## **Appendix C: Noise and Vibration – District and Borough Profiles**

# Mole Valley District Council - Impacts and Mitigations

**MV X1 Additional Residential Properties @ Charlwood captured by predicted increasing N60 exposure from 2019 baseline to 2032 operations of the NRP predicted under Slow transition.**

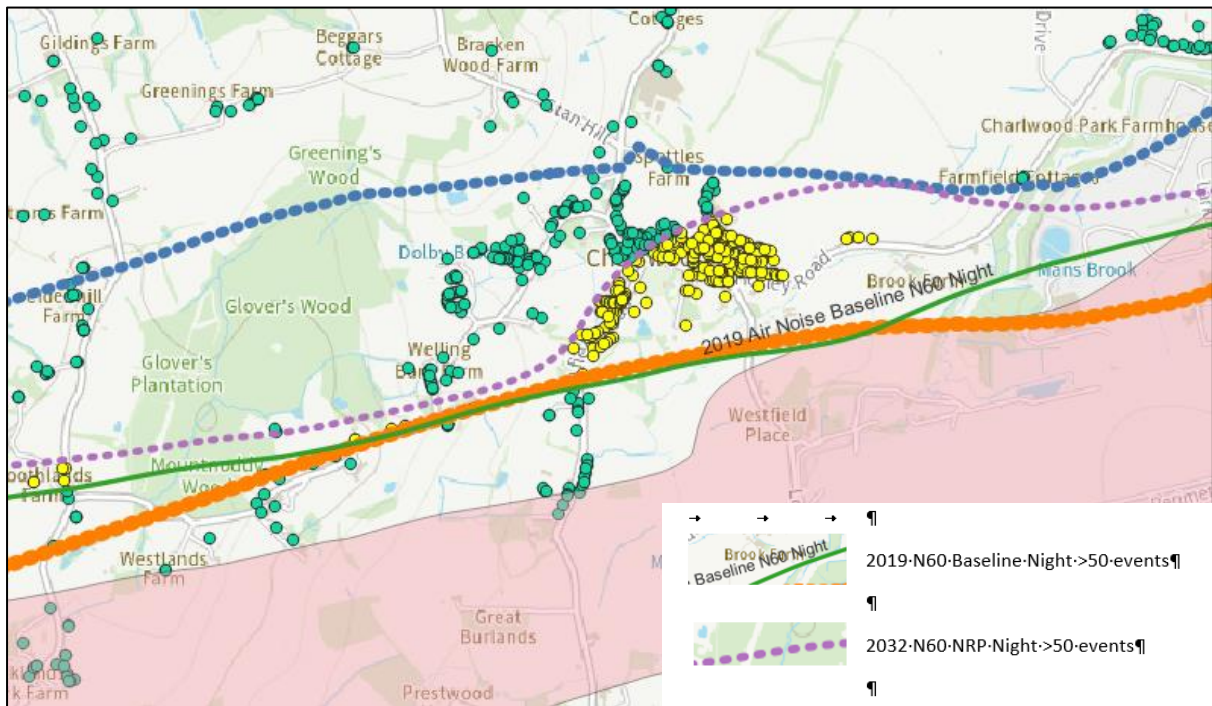
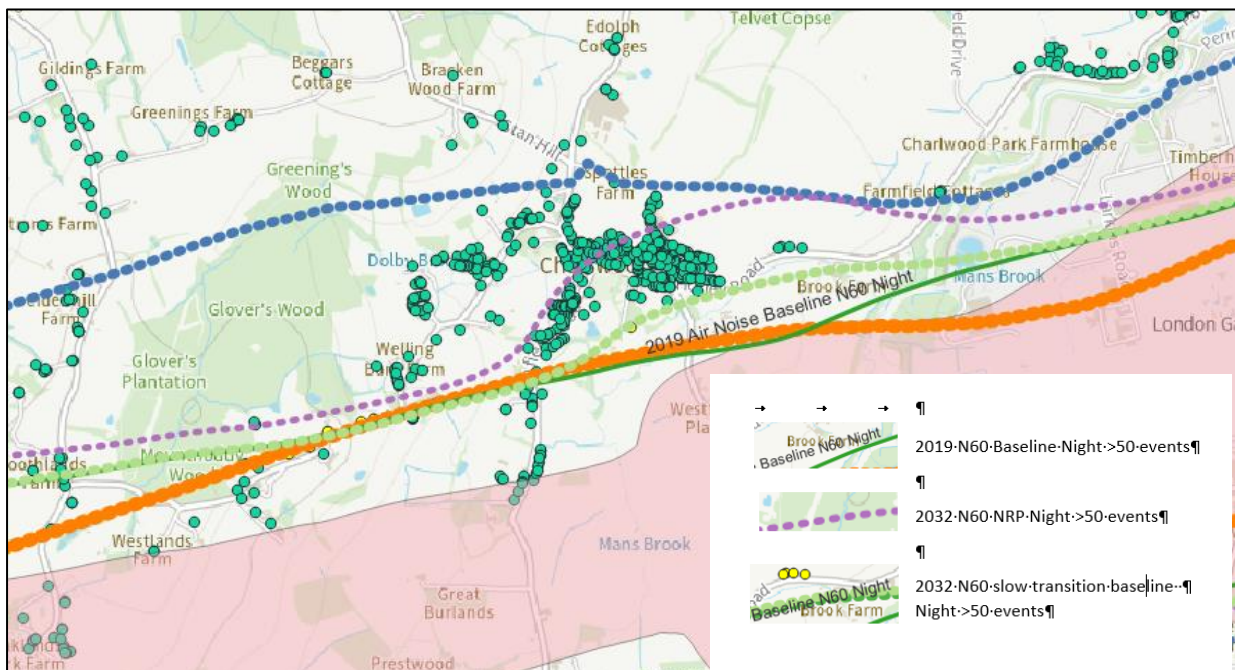
**N60 Events:** The table above and the figures below show the additional impacted residential homes which experience more than 50 noise events of greater than 60dBA in the night time period compared to 2019 with and without the Northern Runway project

The above plan shows there are a negligible number of properties that are impacted by noise events of greater than 60dBA under the base case with no NRP. It can therefore clearly be seen that in the case of Charlwood the increase in adversely impacted residential properties is entirely caused by introduction of the new northern runway

**MV X4 Shows Awakening data provided by GAL for the Charlwood**

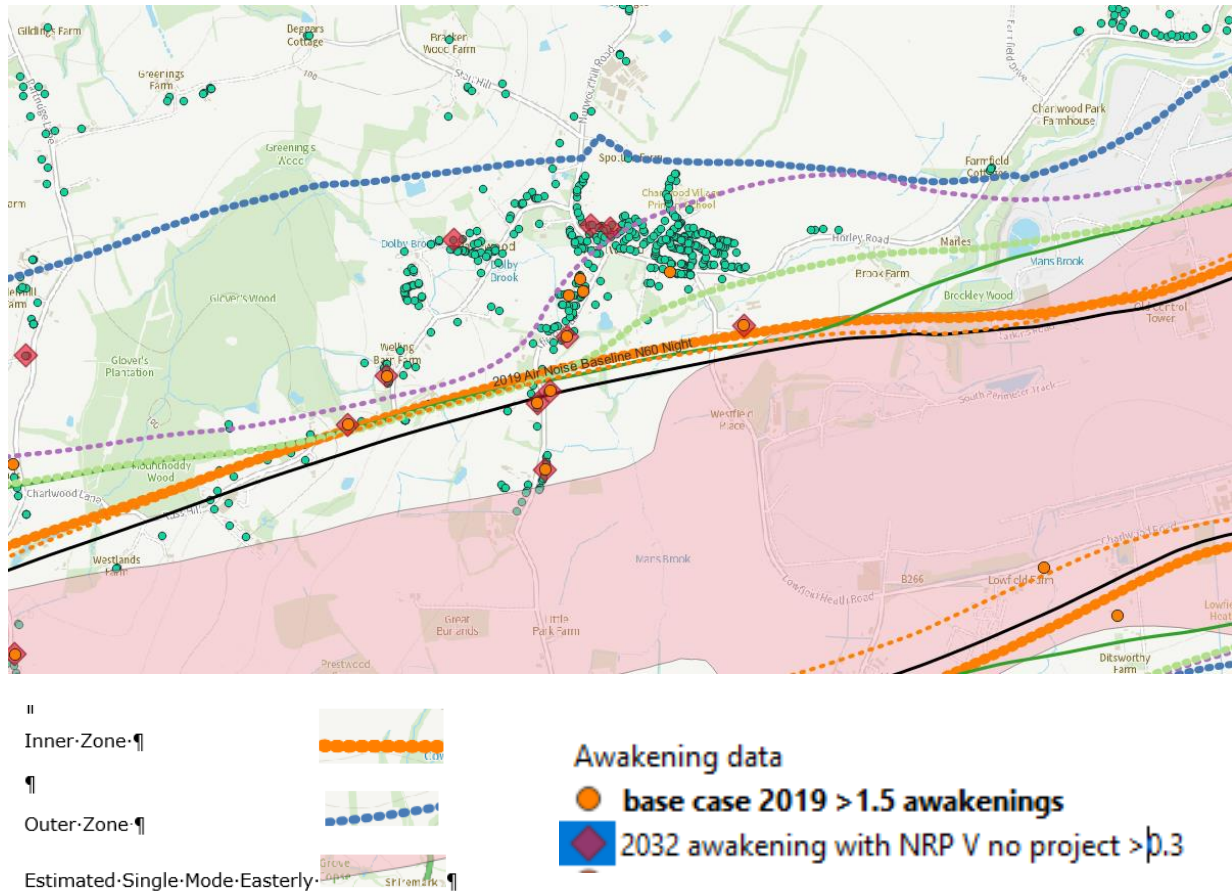
**Awakening Events:** The 2019 base case for Gatwick Airport there are already many location within the District where Gatwick’s own data (not provided within the ES) shows of more than 1.5 events per night. It should be noted that an additional probability of noise induced awakening of more than 1 per night is already a significant adverse effect.

The NRP increases this to 1.8 worsening an already significantly adverse effects are occurring. Policy requires that mitigation is required to avoid these impacts and therefore the noise insulation scheme should significantly revised.

**Figure MV X5 Shows the Impacts on residents for Single Mode 51 dBA contours during Easterly and Westerly Operations.**

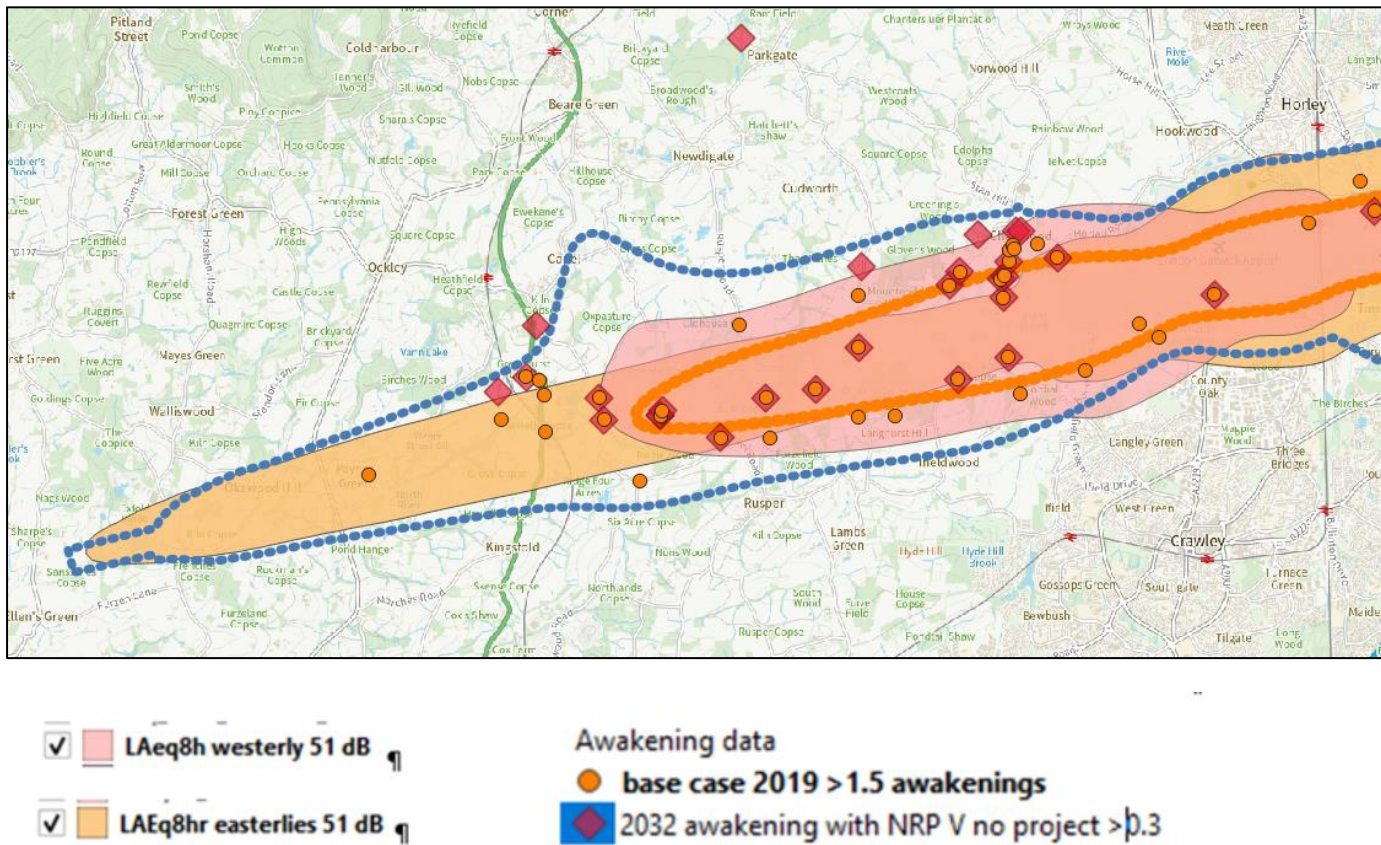
For residents of Mole Valley, when the airport is operating in either westerly or easterly mode, the single mode contours clearly show an increased impact in noise compared with the average mode contours and which is consistent with the awakening data described earlier in the Charlwood area.

This is because the impact shown by the average mode contours rarely if ever actually happens. On any particular day, the airport operations are either single mode westerly or single mode easterly and when aircraft are taking off or landing the noise has a different impact on those people who actually experience it.

**Figure MV-x6 Showing 28 properties within both the higher bandings of 60-63 dBA mitigation payments and the inner insulation zone**

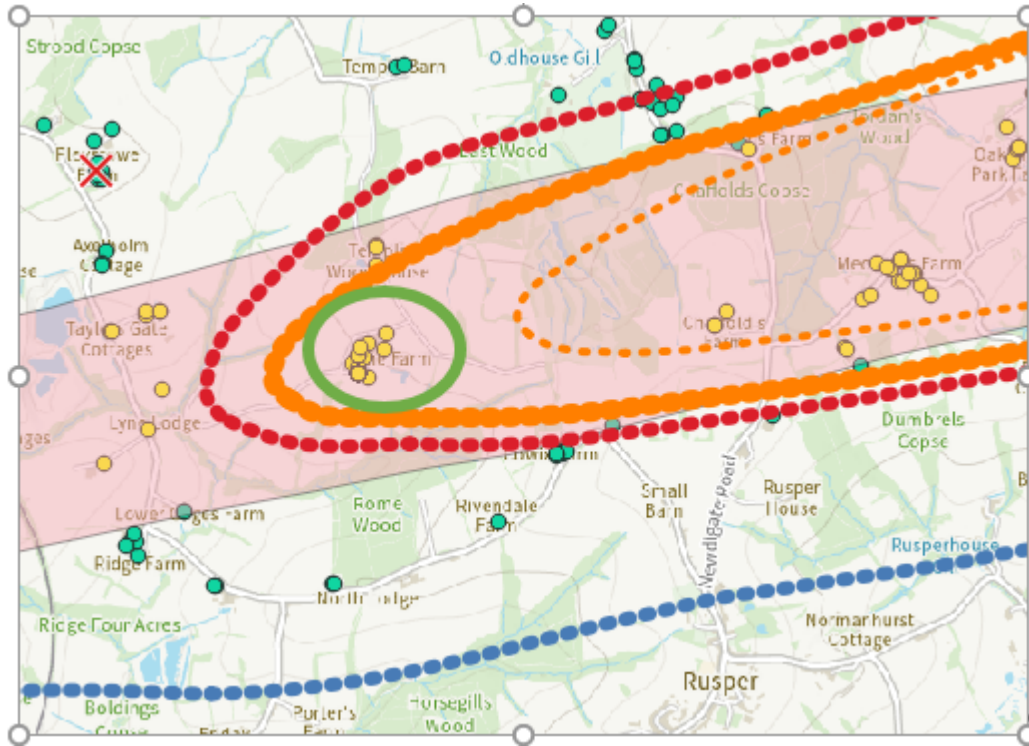
It is unclear how the upper level of noise mitigation at 60 to 63 Leq 16hr and the measures provided for the inner noise insulation zone as currently defined will be resolved and whether residents will be eligible for both schemes.

Figure MV x7

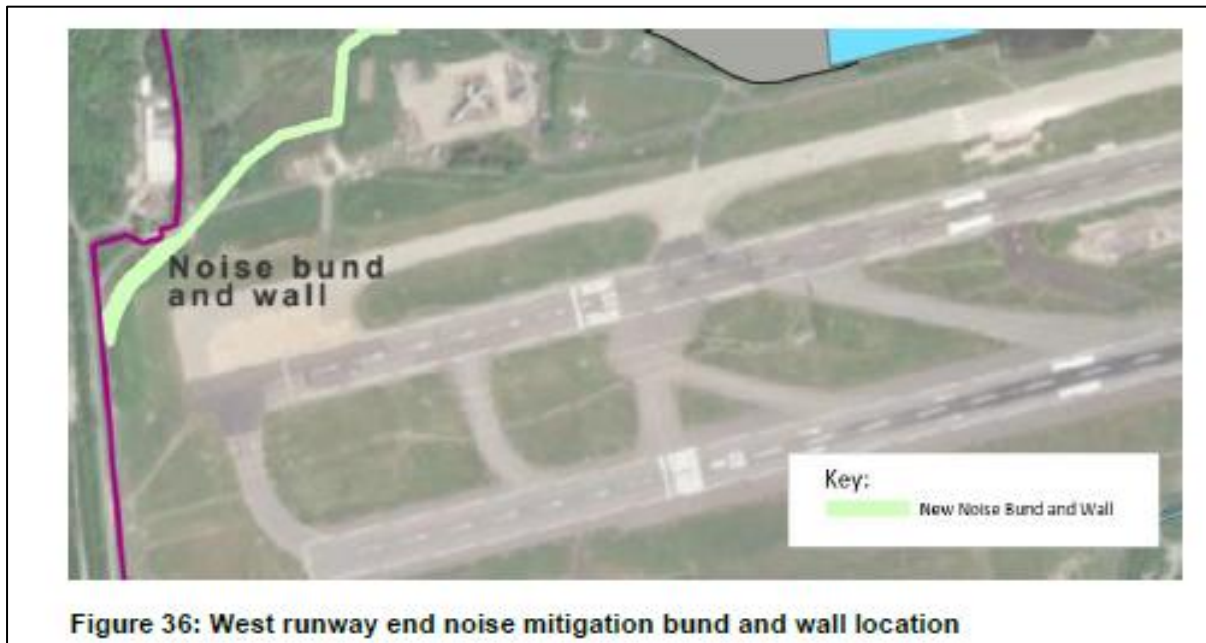
The proposed acoustic barriers and associated bund are to be built following demolition of the existing end of runway mitigation measures but the phasing of the construction is unclear and further information is required including but not limited to:

- When the existing measures will be demolished
- When the new bund and associated concrete panels will be erected
- What the short term impacts on local communities will be
- How long those communities will be without mitigation

**Figure MV x8**

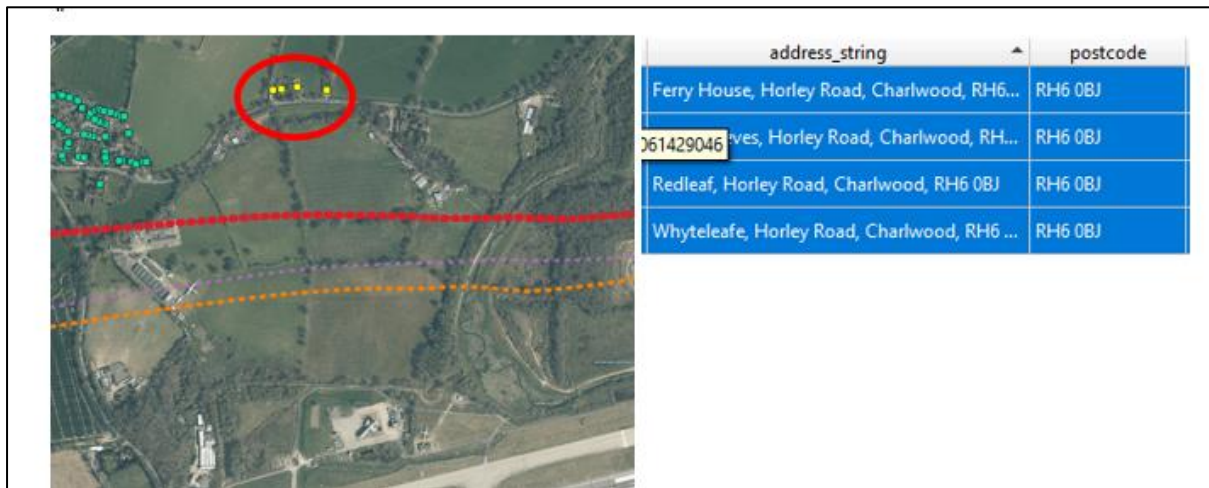
The design parameters of this are unclear and there is no evidence to support what design decisions will be made, the level of mitigation that will be offered or the magnitude of change during the life of the development. In particular the effectiveness of the bund is questioned for the four properties located at RH6 0BJ as shown below:

**Figure MV x8**

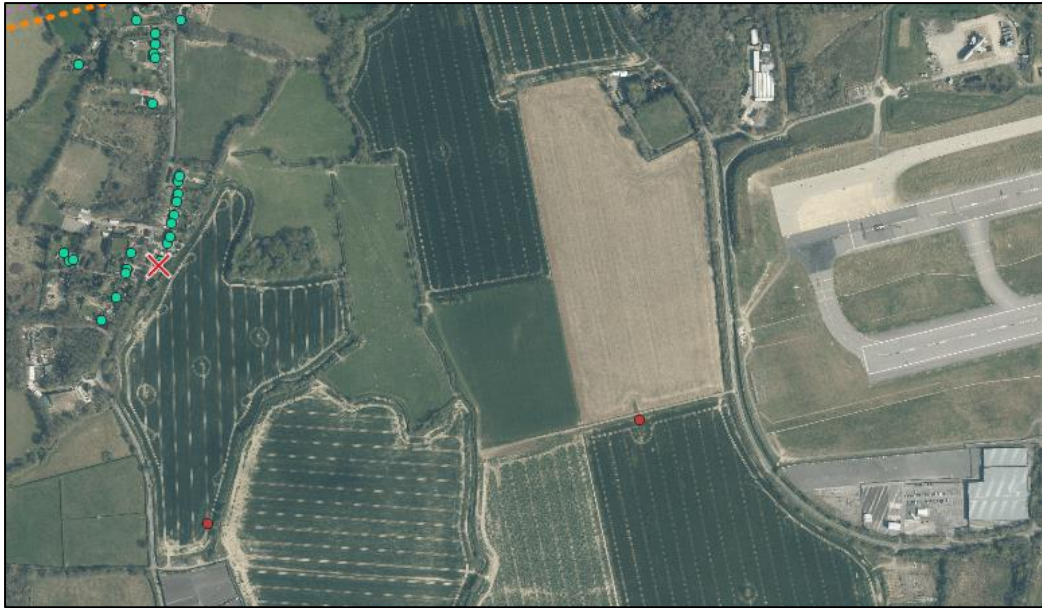
Generally there are multiple sensitive dwellings at these locations and the number of receptors is underestimated.

The figure below illustrates how the impact will affect a number of properties at the Seasons I field Road:

**Figure N2: 2032 With Project noise contours comparing 'averaging' contour of 45 dB  $L_{Aeq, 8hr}$  (green) compared to the same LOAEL for the N60 event based metric of 10 events (red).** (Green hatched area is DCO project boundary, black outline is the Borough of Reigate and Banstead).

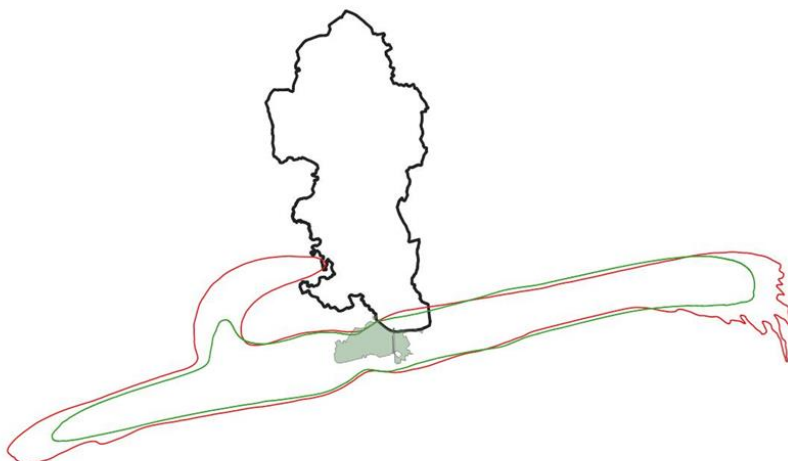
The failure of the  $L_{eq}$  metric to reflect residents noise experience from the impact of the number of aircraft is demonstrated in figure N2 below which shows the night time LOAEL being used by the applicant of 45 dB  $L_{Aeq, 8hr}$  (green line) compared to the same suggested LOAEL for the N60 event based metric of 10 events (red line).

As can be seen in the above figure only using the averaging metric misses adverse effects at the end of the contours, and also misses a large part of the impact of aircraft going round route 4 – the 'red hook' in figure N2.

**Figure N3: Night time Noise Contour area (Top) and Population Affected (bottom) under the Base and with Project Scenarios (central and slow transition cases).**

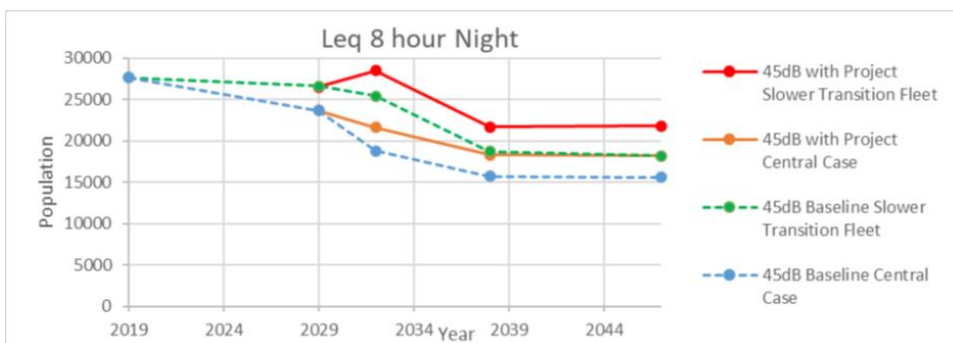
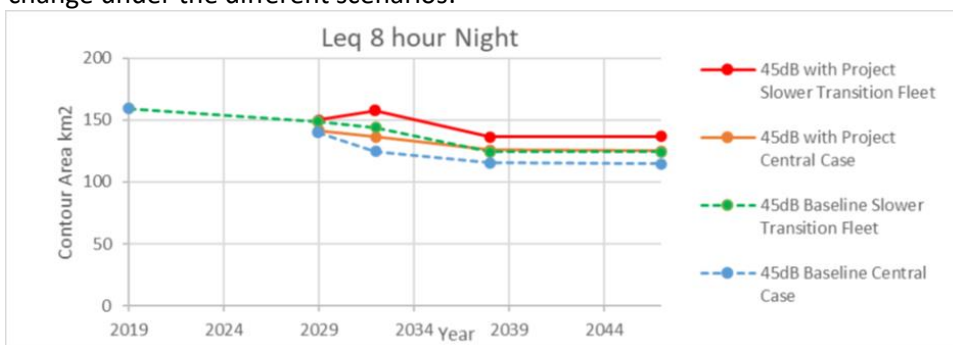
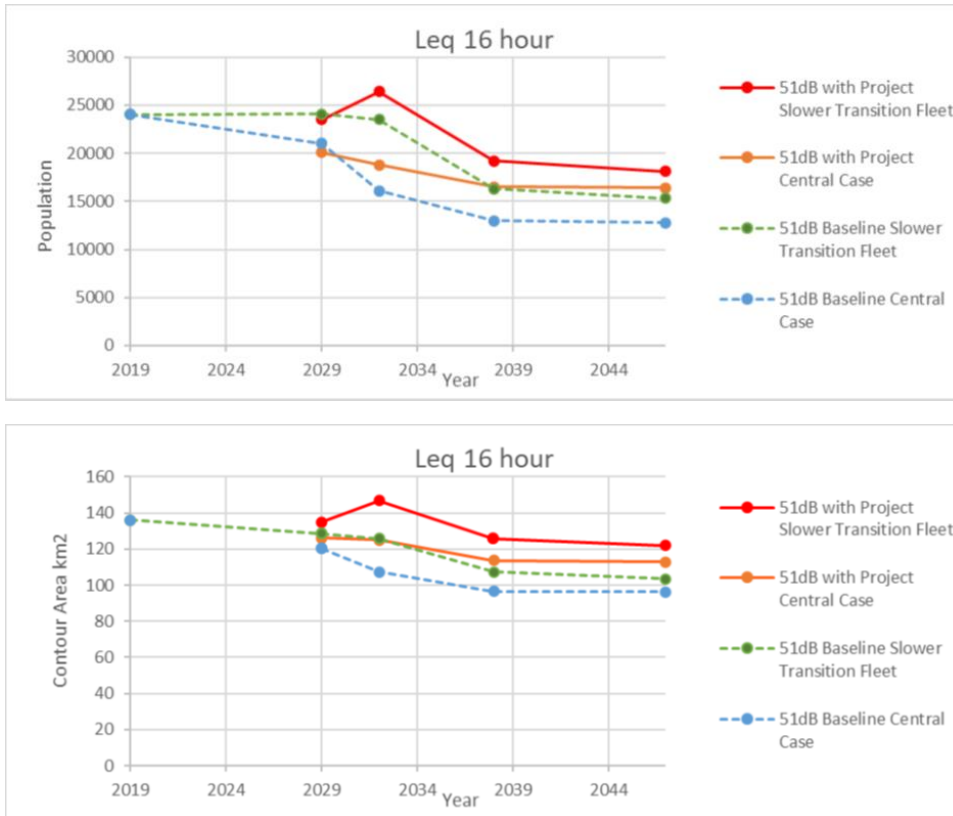
It is clear from the above graphs that by using the slow transition case to set the noise envelope boundaries the airport is in effect allowing itself to create a greater noise impact than was the case in 2019 (both day and night) and under this approach it is difficult to see how any of the technology benefits of quieter aircraft have been shared with the local community.

**i) Envelope needs to be based on Central Case Scenario.**
